COUNCIL SUPPLEMENTARY REPORT

SYDNEY SOUTH PLANNING PANEL

PANEL REFERENCE & DA NUMBER	PPSSSH-154 – DA 2023/0487
PROPOSAL	Demolition works, marina expansion, construction of a new carpark, alterations and additions to the existing club
ADDRESS	2 Wellington Street, Sans Souci (Gorges River LGA) – Lot 1 DP 956068, Lots 1, 2 & 3 DP 1012626, Lot 5A Sec 9 DP 1816, Lot 1 DP 957802, Lot 1 DP 441596, Lot 1 DP 106035, Lot 1 DP 78902
APPLICANT	The St. George Motor Boat Club Ltd
OWNER	The St. George Motor Boat Club Ltd
DA LODGEMENT DATE	25 October 2023
APPLICATION TYPE	Development Application - Designated (s4.10 of EP&A Act & Schedule 3 of Regulations) & Integrated Development (s4.46 of the EP&A Act)
REGIONALLY SIGNIFICANT CRITERIA	Section 2.19(1) and Clause 7(1)(b) of Schedule 6 of <i>State Environmental Planning Policy (Planning Systems) 2021</i> declares it regionally significant development as it proposes Particular Designated Development being marinas or related facilities that meet the requirements for designated development under Schedule 3, section 32 of the <i>Environmental Planning and Assessment Regulation 2021</i>

Figure 6: Removal of roof terrace and inclusion of parapet (Source: Innovate, Revision F)

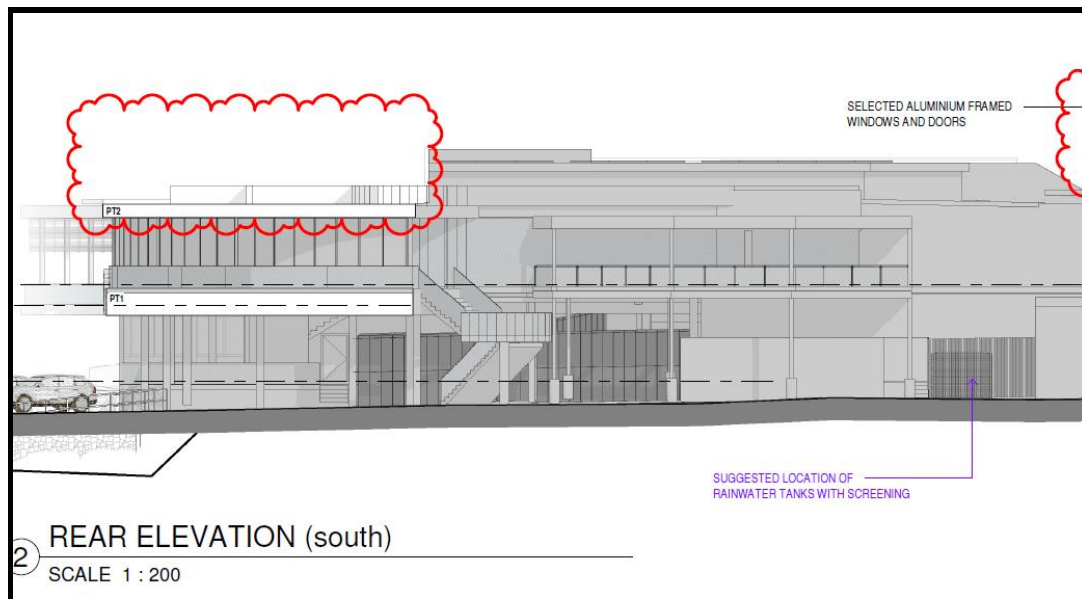
The rooftop terrace has been removed in the amended proposal and a parapet is proposed to screen the existing plant equipment from the foreshore (**Figure 6**). This has reduced the bulk of the development to the foreshore and is consistent with the Panel's record of deferral dated 28 October 2024 (**Figure 7**).

Council's Senior Specialist Planner (Urban Design) still has some concerns with the horizontality of the design, the proportion of glazing and the lack of details on the landscape plan for planting along the foreshore boundary, which would assist in screening the development. Therefore, consent conditions are recommended including that a schedule of external colours and materials are to be provided and a final landscape which outlines in more detail the tree planting along the foreshore frontage. These details are required to be provided and approved by Council's Urban Design Officer prior to the issue of a Construction Certificate (**Attachment A**).

Figure 8: Proposed Height exceedances - Amended Proposal (Source: Innovate, Revision F)

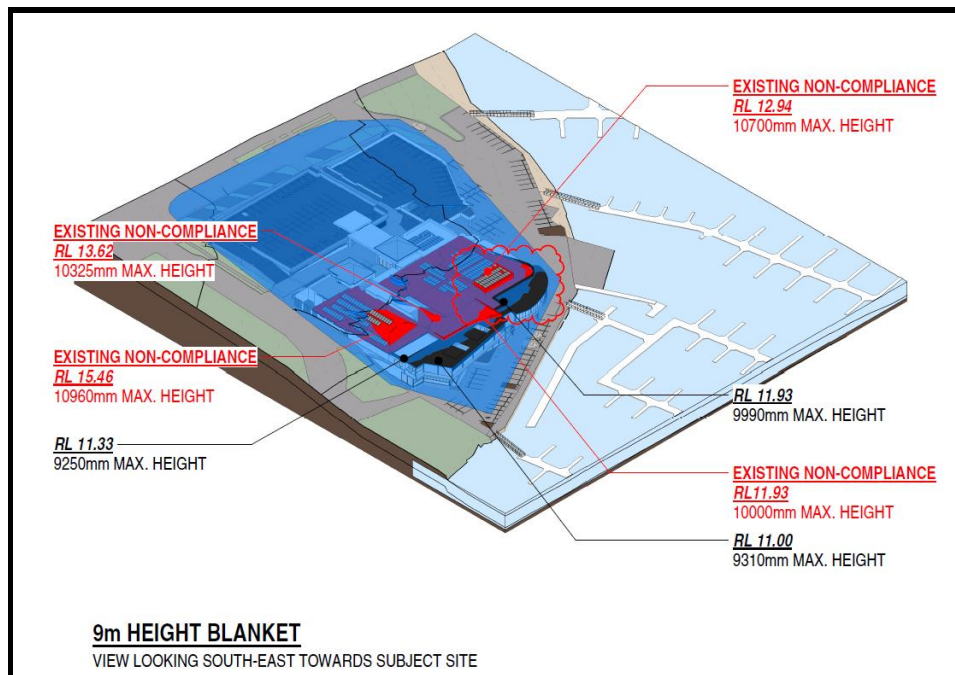
A Clause 4.6 has been provided as there are some components of the proposal which exceed the maximum height of building development standards pursuant to Clause 4.3(2) of the GRLEP 2021. While the amended proposal still exceeds the maximum height development standard, the number and extent of these exceedances has been reduced following the deletion of the formerly proposed rooftop terrace and the reduction in the height of the roof over the entry. The height exceedances are illustrated in the height blanket diagram in **Figure 8** below.

- The environmental planning grounds relied upon for each height exceedances comprise the following:
 - Roof parapets - Minimal bulk and dimension and will tie in with some of the existing roof parapet, with exceedances ranging from 250mm-999mm to screen existing roof services. This will improve the appearance of the building from the water and will not be visible from the street due to existing other roof features closer to the streets.

Figure 10: Increased setback to Plimsoll and Wellington Streets (Source: Innovate, Revision F)

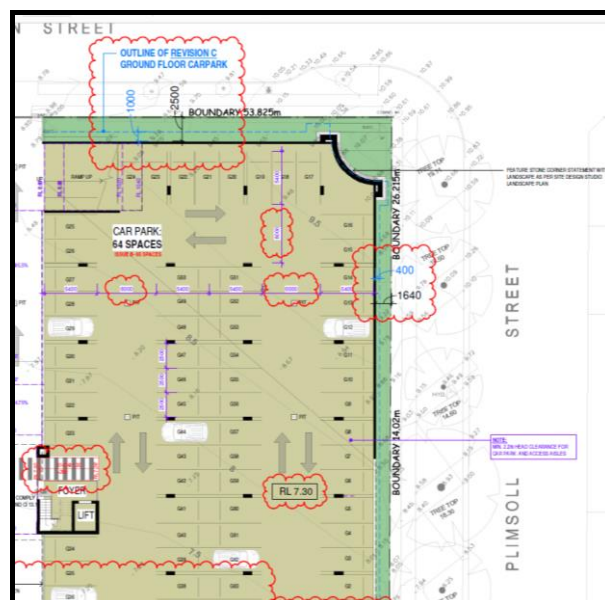
While the setbacks to the street have been increased in accordance with the Panel's deferral, the revised Landscape Plan does not illustrate any additional planting in these setback areas, which was requested in the Panel's deferral (point (e)). In particular, the Plimsoll Street boundary still consists only of the Lilly Pilly straight and narrow trees and a single row of Blue Flax Lily's (grasses), with the dusky coral pea (climber or groundcover) having been removed from the Plan.

It is considered that greater layers of landscaping should be provided particularly along the Plimsoll Street boundary to provide screening of the blank wall and lower level of cars when viewed from the street. This is included as a recommended consent conditions in **Attachment A**.

Figure 12: Amended Landscape Plan with landscaping adjoining the access driveway (Source: Site Design Studios, Revision D)

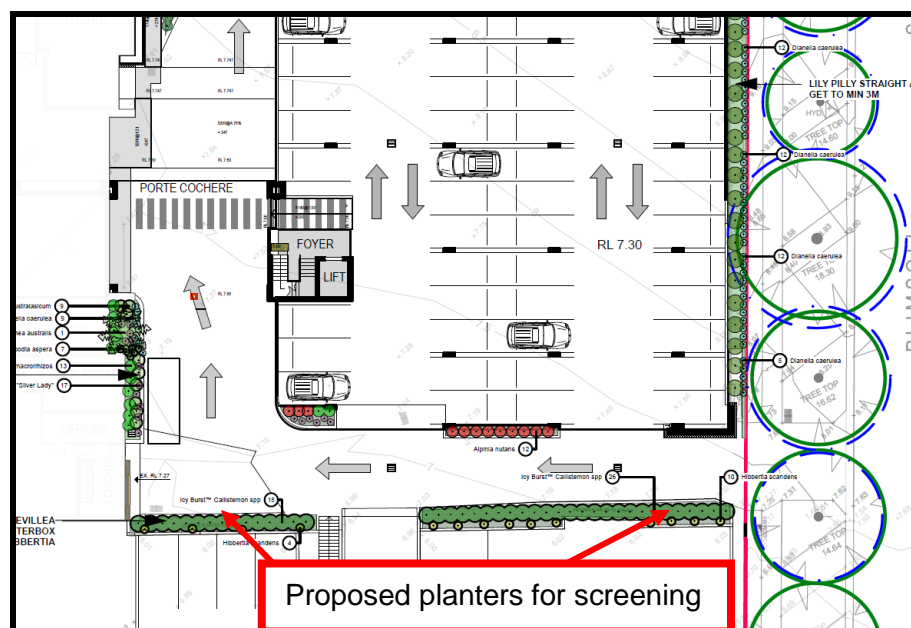
The amended proposal involves the provision of aluminium screening adjoining the driveway entry along the southern section of the car park to screen the car park from the foreshore (Figure 11). The amended proposal also includes the reinstatement of the existing planters

along the southern edge of the access driveway from Plimsoll Street (**Figure 12**). This will assist in screening the car park and access driveway from the foreshore consistent with the Panel's deferral (outlined in (f) above). Relevant consent conditions are recommended in **Attachment A** for the proposal to be consistent with the landscape plan.

Figure 14: Proposed temporary construction vehicle access (Source: Innovate, Revision F)

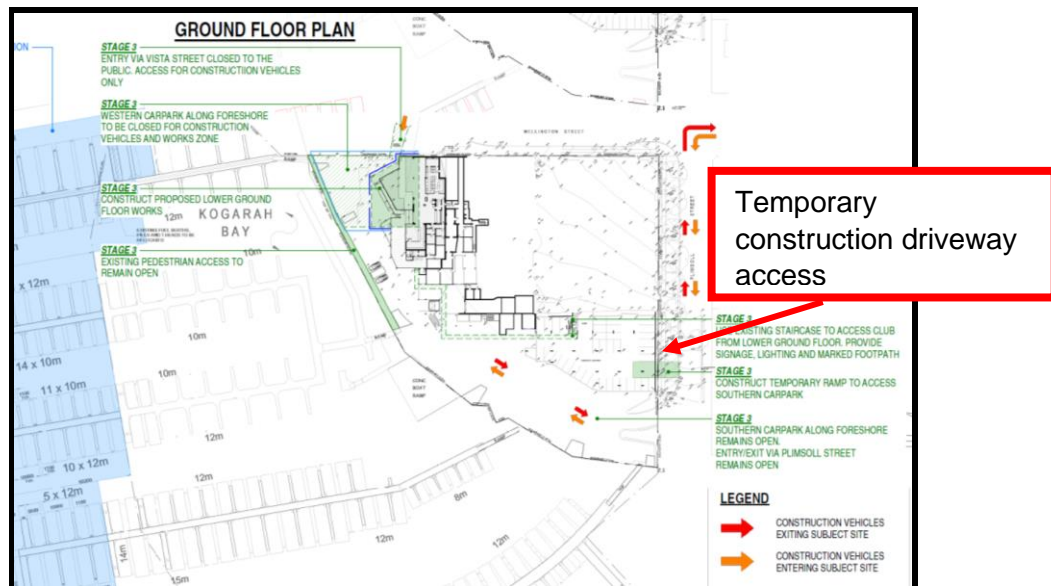
A temporary ramp and vehicle crossing is also proposed at the southern end of the Plimsoll Street boundary of the site, shown as “*Stage 3 Construct Temporary Ramp to Access Southern Carpark*” on “*Construction Management Plan -Stage 3 - Sheet 54*” (**Figure 14**). This access point will require approval from officers in Council’s Assets and Infrastructure Directorate with relevant consent conditions recommended included in **Attachment A**.

It is also noted that the construction staging is inconsistent between the architectural plans and the Construction Noise and Vibration Management Plan (**CNVMP**), with the plans indicating the marina works are to be in Stage 2, while the CNVMP outlines the marina works are to be carried out in Stage 3. Relevant consent conditions recommended are included in **Attachment A**.

Figure 26: Montage of impact from amended proposal for ground floor of No 44 Plimsoll St
(Source: Rock Hunter Australia, Nov 2024)

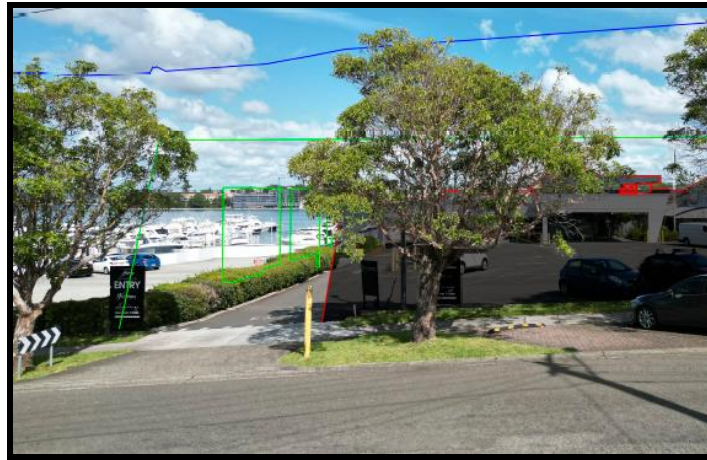
- **No 44 Plimsoll Street** – The ground floor view is assumed to be from a living room and includes the land water interface on the opposite side of the River (near Tom Ugly's Bridge). This view is more highly valued as it is more of a whole view than the other views enjoyed along this road. The ground floor view is now retained given the removal of the southern section of the first floor of the car park (**Figure 26**), while the first floor view is now also retained by the amended proposal (**Figure 27**). This was one of the properties which experienced unacceptable view loss under the previous version of

the proposal, however, it is now considered that the view sharing for this property is satisfactory having regard to the amended proposal.

Figure 30: Previous proposal (Source: Innovate, Revision C)

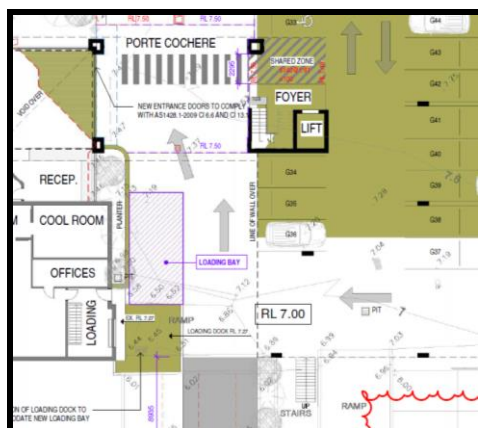
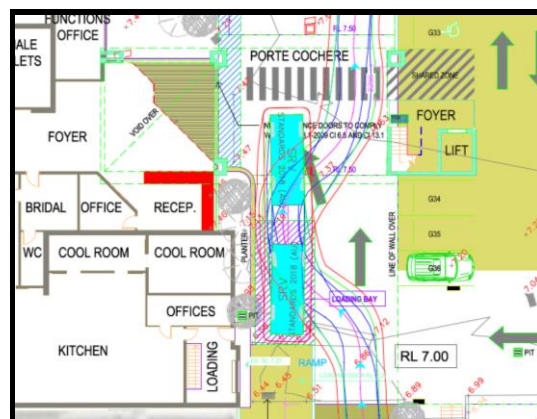
There were concerns with the previously proposed extension to the existing ground floor loading dock as there were pedestrian safety issues arising from the manoeuvring across the main pedestrian crossing under the porte cochere from the new car park (**Figure 30 & 31**).

Figure 32: Amended Proposal (Source: Innovate, Revision F)

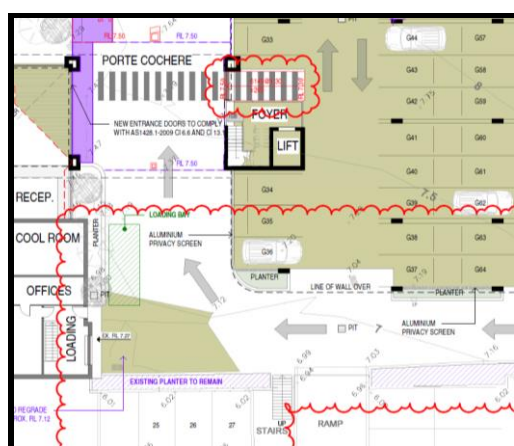
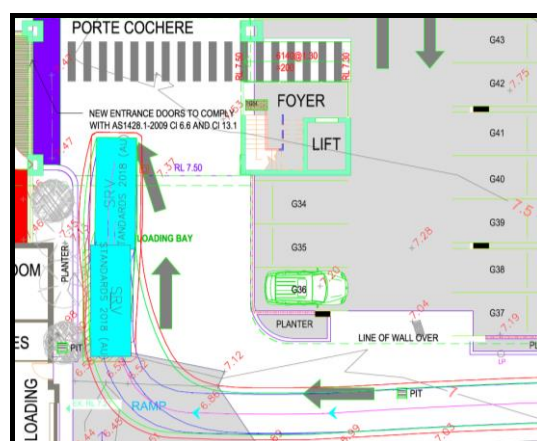
The amended proposal involves SRV access from Plimsoll Street from the existing vehicle access driveway (and removal of the previously proposed internal ramps and separate SRV access in Revision C). The amended proposal also involves minor filling in front of this existing ground floor loading dock to allow SRV's to access this loading dock in a parallel position, with manoeuvring paths to be slightly more distant to the pedestrian crossing than the previous proposal (Figures 32 & 33).

Council's Traffic Engineer has considered the swept paths provided which were completed using *AutoTURN 11* software, the standard SRV template in accordance with AS2890.2:2018 and the standard B99 template in accordance with AS2890.1:2004. The resultant swept paths are successful, with an SRV able to enter and exit the proposed loading bay in a total of three (3) manoeuvres which is the minimum number of possible manoeuvres. Simultaneously, a B99 vehicle is able to manoeuvre past the proposed SRV loading bay without vehicular conflict. Therefore, the proposed loading dock and subsequent circulation roads are considered acceptable.

Figure 34: Previous proposed roof over main entry (Source: Innovate, Rev F)

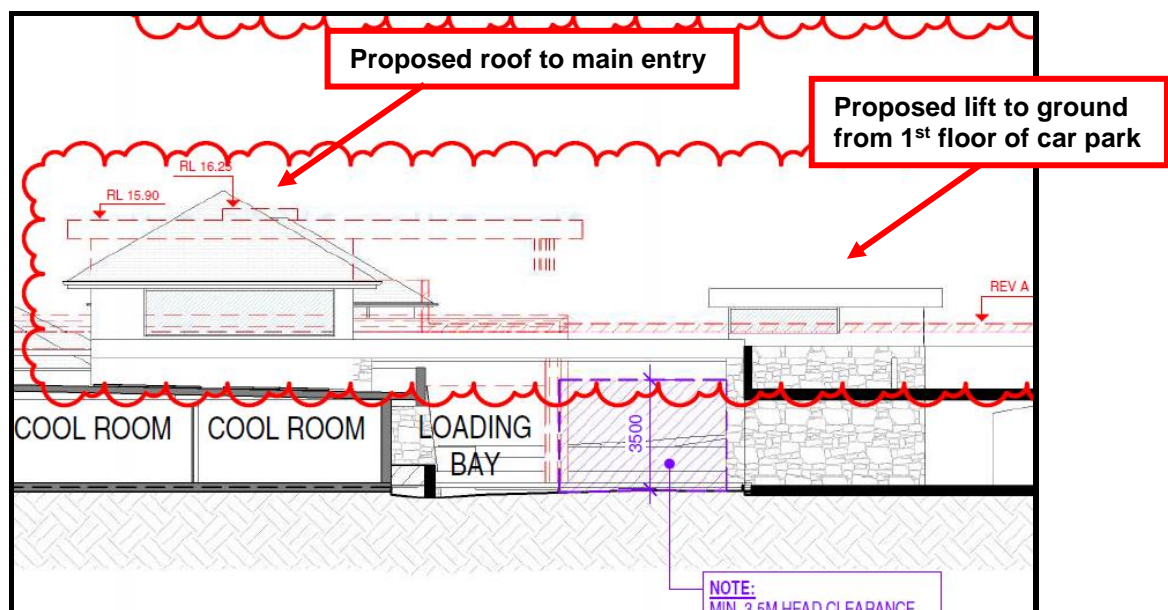
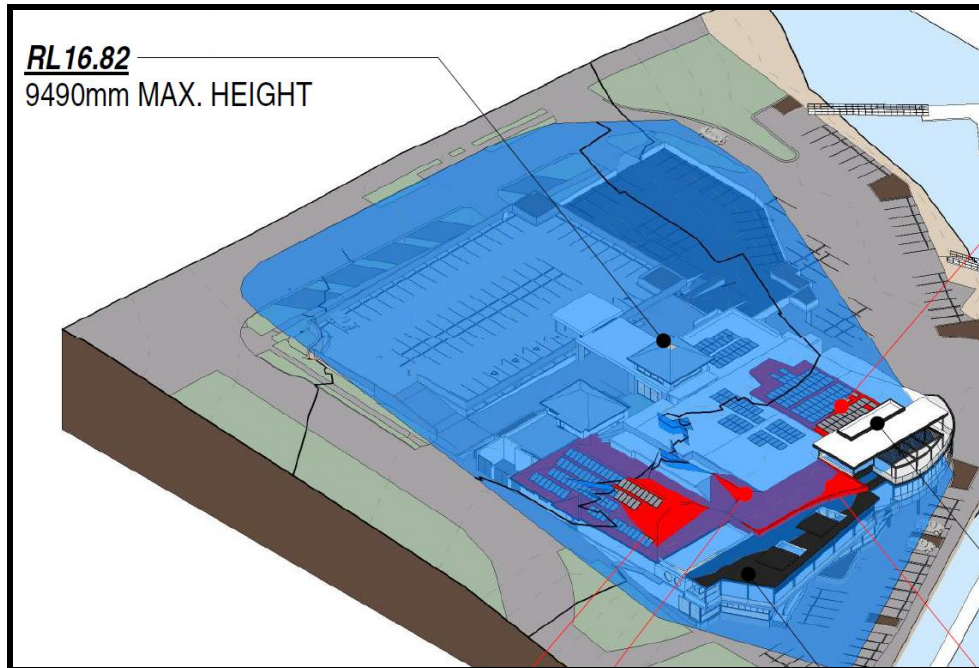
While this is only a minor variation to the height limit, it is considered that this roof form is unnecessarily high and bulky given it is over a void area with no floor area below. This proposed new roof form is also significantly higher than the lift well from the car park adjoining to the east as well as the existing roof form over the existing office area to the north on the first floor. While the pitched form of the roof is supported, as it is compatible with the existing roof on the club building as well as the residential dwellings in the area, the overall height is excessive and unnecessary.

The original roof was proposed at a height of 9.49 metres (RL 16.82) (**Figure 34**), which exceeded the height limit as shown on the height blanket diagram (**Figure 35**).

Figure 36: Proposed new roof over entry (Source: Innovate, Revision F)

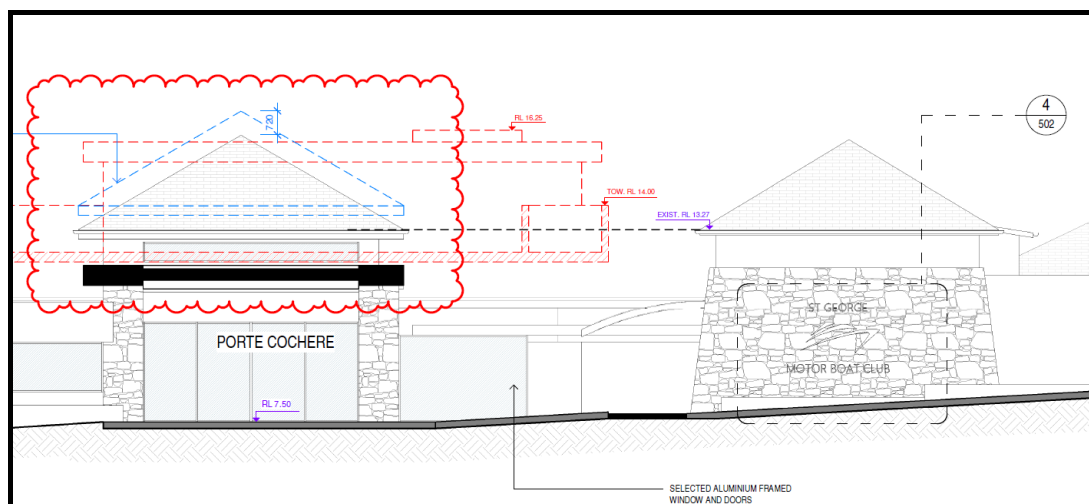
The amended proposal involves the lowering of this roof over the main entry to a height of 8.77 metres (RL 16.1), which is below the maximum height limit of 9 metres (Figure 36). Council's Senior Specialist Planner (Urban Design) still has concerns regarding this proposed new roof, given the potential impact to views and the proposed height of the roof. The revised photomontages in relation to view loss indicate that this proposed new roof has only a minor impact on distant views towards Blakehurst and does not significantly impact water views from properties along Plimsoll and Wellington Streets.

However, the height of this new roof and the existing roof on the first floor (over the existing office area) are not shown on the plans (height is calculated from the height blanket diagrams) and therefore it is unclear whether the proposed new roof is the same height or higher than the existing first floor roof. It is considered that this new roof over the entry should be limited in height to that of the existing first floor roof (over the office on the first floor). Accordingly, a consent condition is recommended in **Attachment A**.

Figure 38: Amended Foreshore Planter (Source: Innovate, Revision F)

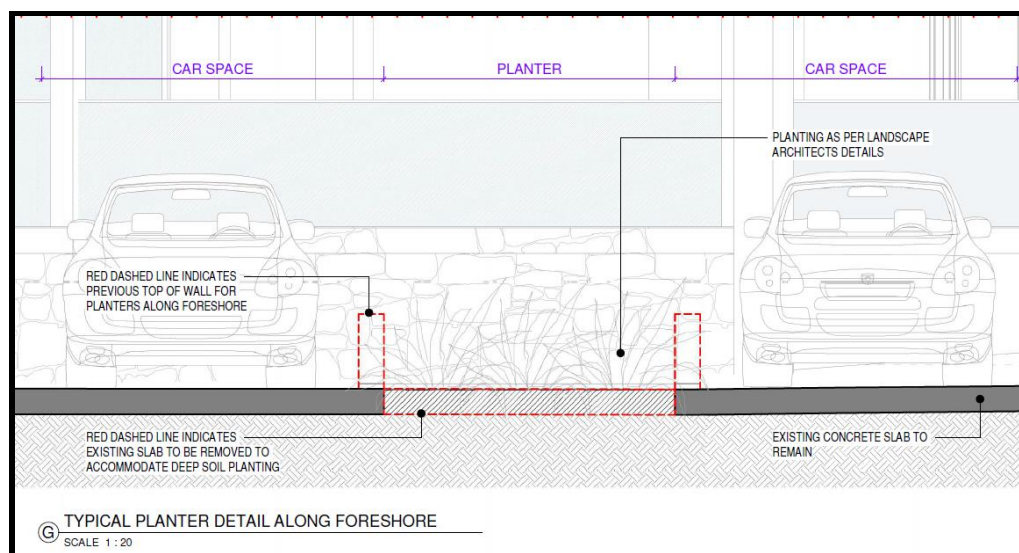
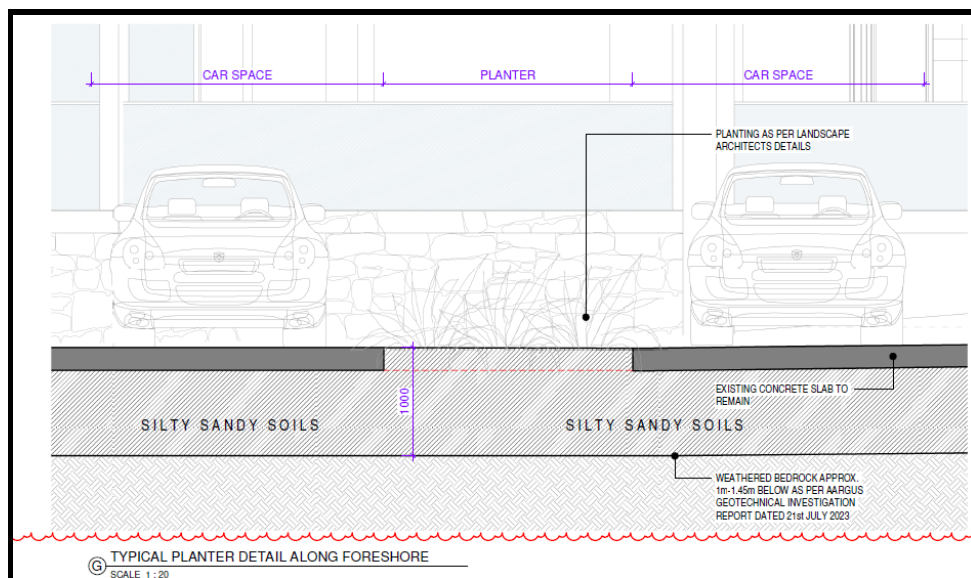
The concerns raised in Council's Assessment Report in relation to the foreshore landscaping involved the lack of soil depth for the planting of significant trees to screen the development from the foreshore (**Figure 37**). In the deferral, the Panel specifically sought clarification in relation to whether the proposed planting areas along the foreshore are of sufficient depth to sustain trees and landscaping with species consistent with Council's requirements.

The amended proposal now illustrates a planting depth of 1 metre below the proposed foreshore planters (**Figure 38**), with Tuckeroos replaced with Coastal Banksias. Council's Landscaping Officer supports the Revised Landscape Plan, including the proposed Coastal Banksia trees. However, the tying of 100L trees to stakes outlined in the Revised Landscape Plan is not supported as 100L trees are self-supporting when grown in accordance with AS2303 – 2018, *'Tree stock for landscape use'*. There were also concerns raised from Council's urban design officer that these trees were not adequately outlined on the revised Landscape Plan and that the trees are to be a minimum of medium trees which are capable

of a mature height of between 8 and 12 metres. This is required to providing screening to the development. Landscape consent conditions are included in the draft consent conditions in **Attachment A**.
